AMENDMENT NO. 1 to
APPLICATION FOR AMENDMENT TO
OPERATING LICENSE

RESPONSES TO SEPTEMBER 1, 1977 QUESTIONS BY NRC

RESPONSES TO SEPTEMBER 16, 1977 QUESTIONS BY NRC

TYPE "A" RACK
FUEL STORAGE CELL - CROSS SECTION
INDIAN POINT 3 NUCLEAR POWER PLANT

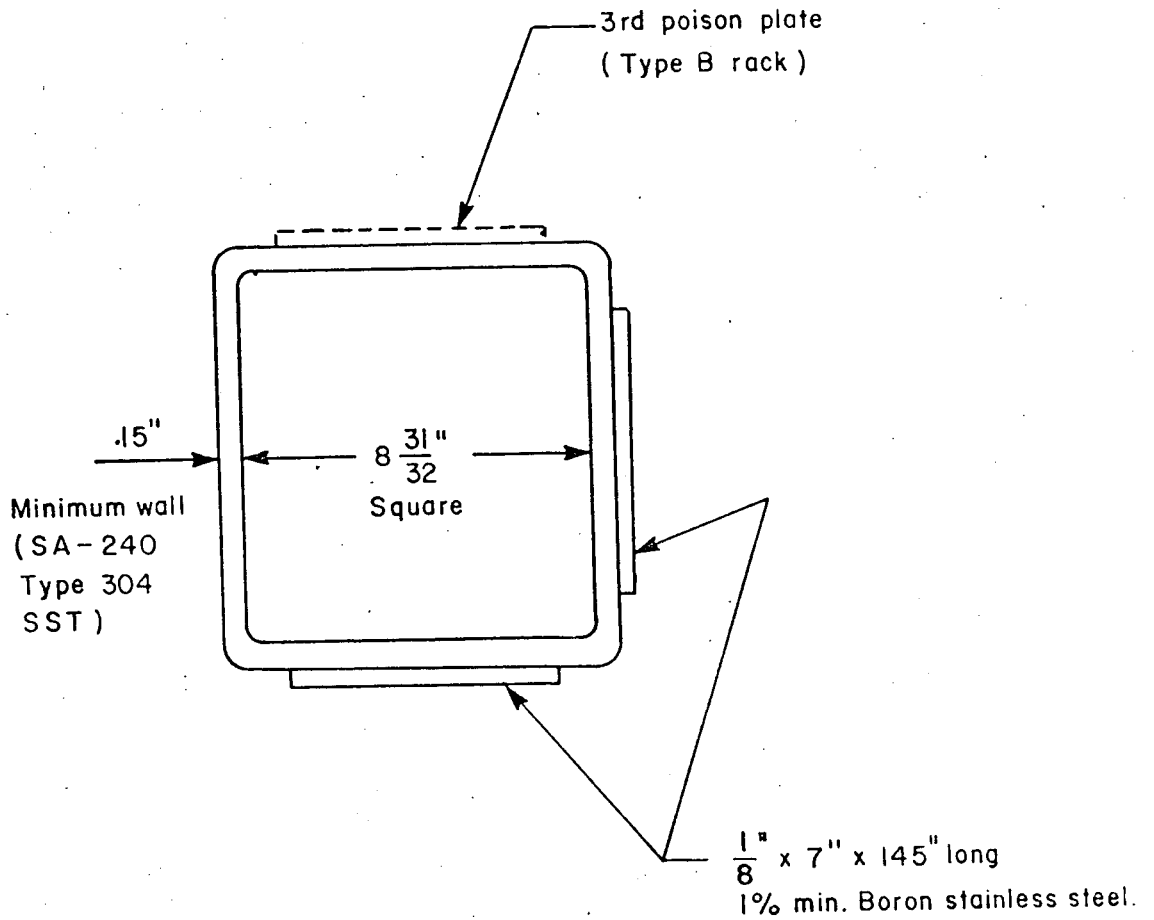
I.6. State the type and minimum thickness of stainless steel that is proposed to be used for the storage containers on to which the borated plates are to be welded. Provide a cross sectional sketch of the containers with dimensions.

A cross sectional sketch is provided as Attachment A.
